APPENDIX J.10

COMMENTS ON DRAFT ESR AND RESPONSES

**Re: Schedule 'C' Class Environmental Assessment Study
Ninth Line (Regional Road 13) Transportation Corridor Improvements, Town of Halton Hills
Project Team Response to Halton Region Engineering and Construction Department
Comment on Draft Environmental Study Report**

**Re: Ninth Line Transportation Corridor Improvements - Region of Halton PR2876
Draft ESR (UEM - March 2015) – CH Comment
CH File: MPR 664 - Ninth Line Class EA**

Figure 1

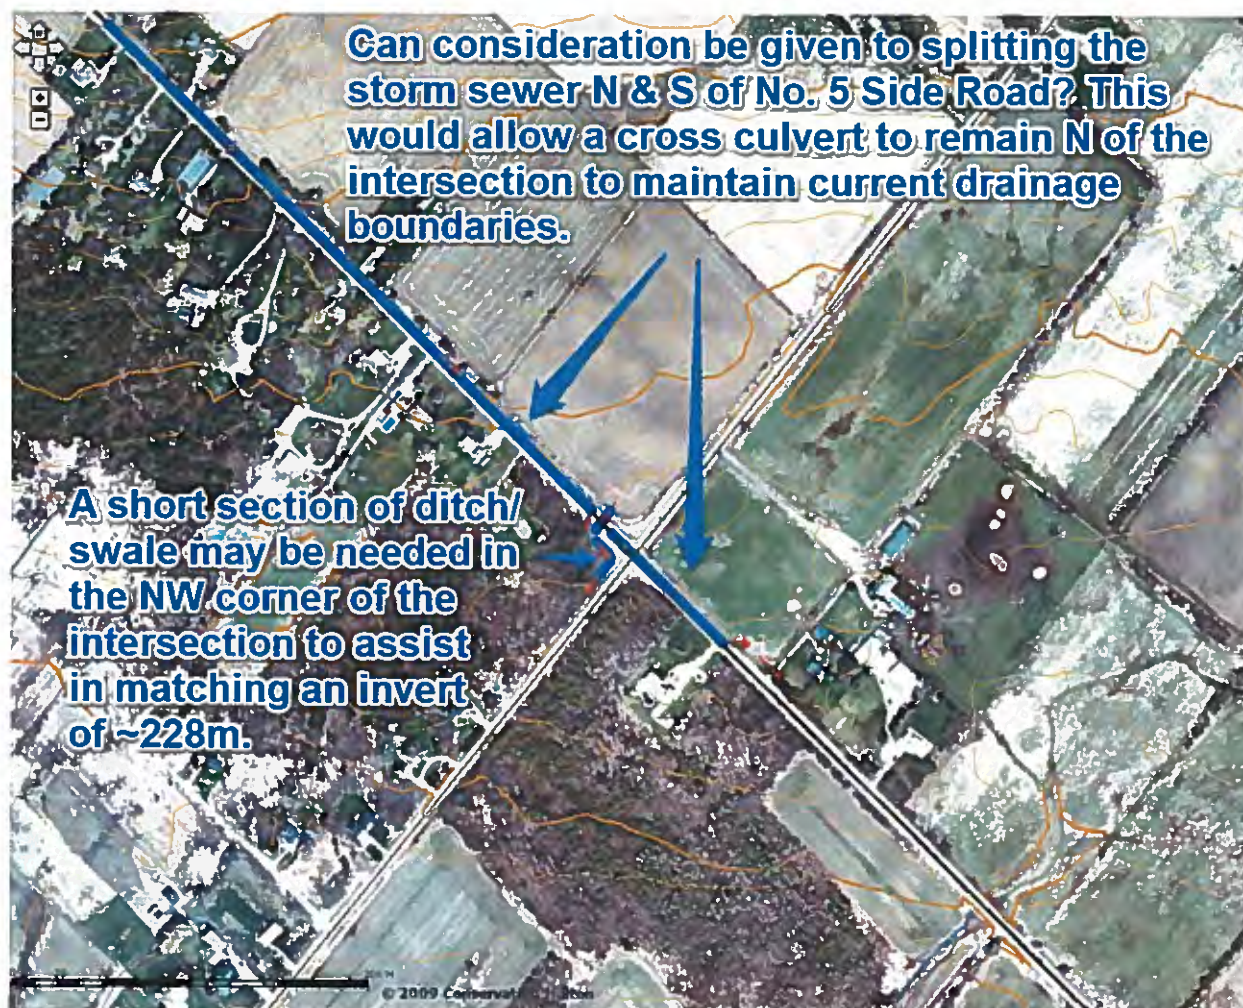
3. Further to our February 25, 2016 comments on the draft SWM Report (item 7, page 2) – *“Please provide additional discussion and clarification/rationale for the diversion of the 7.9 hectares in Area N2B to the south”* we note that this comment has been partially addressed. Page 104 includes the following text “...the potential impact of the modified flow route on wetland water balance will be assessed and addressed during detailed design.” The impacts of the drainage diversion, which are a result of the proposed changes to the road, should be assessed as part of the EA and not left to detailed design. If the proposed urbanization of the road section through this area prohibits maintenance of the existing 8ha of drainage to the wetland/woodlot feature west of Ninth Line and North of No. 5 Side Road, the preferred design and/or urban cross section for the road section will need to be revised to accommodate existing drainage patterns. There is a commitment provided in Table 7-3, Section 1b that recommends verifying the water balance and impact to the wetland during detailed design however the feasibility of this option should be reviewed prior to the approval of the EA. In reviewing the design concepts in Appendix K of the ESR (8 of 22 through to 11 of 22), staff request that consideration be given to splitting the storm sewer into two sections, one north of No. 5 Side Road and one to the south. This approach would allow a cross culvert to remain north of the intersection to maintain current drainage boundaries. It would also have the benefit of reducing pipe sizes to the south. For the pipe sections where frost depth cannot be achieved (between MH6 and headwall for north section), insulation could be considered. Alternatively, the north section could end at MH6 and discharge into a short ditch as is proposed to the south of the intersection. A short section of roadside ditch/swale may be needed on the NW corner of the intersection to assist in achieving/matching an invert of approximately 228m. *See attached Figure 1 for additional information.*

Comment #3: Further to our February 25, 2016 comments on the draft SWM Report (item 7, page 2) – *“Please provide additional discussion and clarification/rationale for the diversion of the 7.9 hectares in Area N2B to the south”* we note that this comment has been partially addressed. Page 104 includes the following text *“...the potential impact of the modified flow route on wetland water balance will be assessed and addressed during detailed design.”* The impacts of the drainage diversion, which are a result of the proposed changes to the road, should be assessed as part of the EA and not left to detailed design. If the proposed urbanization of the road section through this area prohibits maintenance of the existing 8ha of drainage to the wetland/woodlot feature west of Ninth Line and North of No. 5 Side Road, the preferred design and/or urban cross section for the road section will need to be revised to accommodate existing drainage patterns. There is a commitment provided in Table 7-3, Section 1b that recommends verifying the water balance and impact to the wetland during detailed design however the feasibility of this option should be reviewed prior to the approval of the EA. In reviewing the design concepts in Appendix K of the ESR (8 of 22 through to 11 of 22), staff request that consideration be given to splitting the storm sewer into two sections, one north of No. 5 Side Road and one to the south. This approach would allow a cross culvert to remain north of the intersection to maintain current drainage boundaries. It would also have the benefit of reducing pipe sizes to the south. For the pipe sections where frost depth cannot be achieved (between MH6 and headwall for north section), insulation could be considered. Alternatively, the north section could end at MH6 and discharge into a short ditch as is proposed to the south of the intersection. A short section of roadside ditch/swale may be needed on the NW corner of the intersection to assist in achieving/matching an invert of approximately 228m. *See attached Figure 1 for additional information.*

Response #3: The Project Team held a meeting with Conservation Halton staff on April 21, 2016 to explore this alternative. UEM revised the preferred design to incorporate this concept to maintain
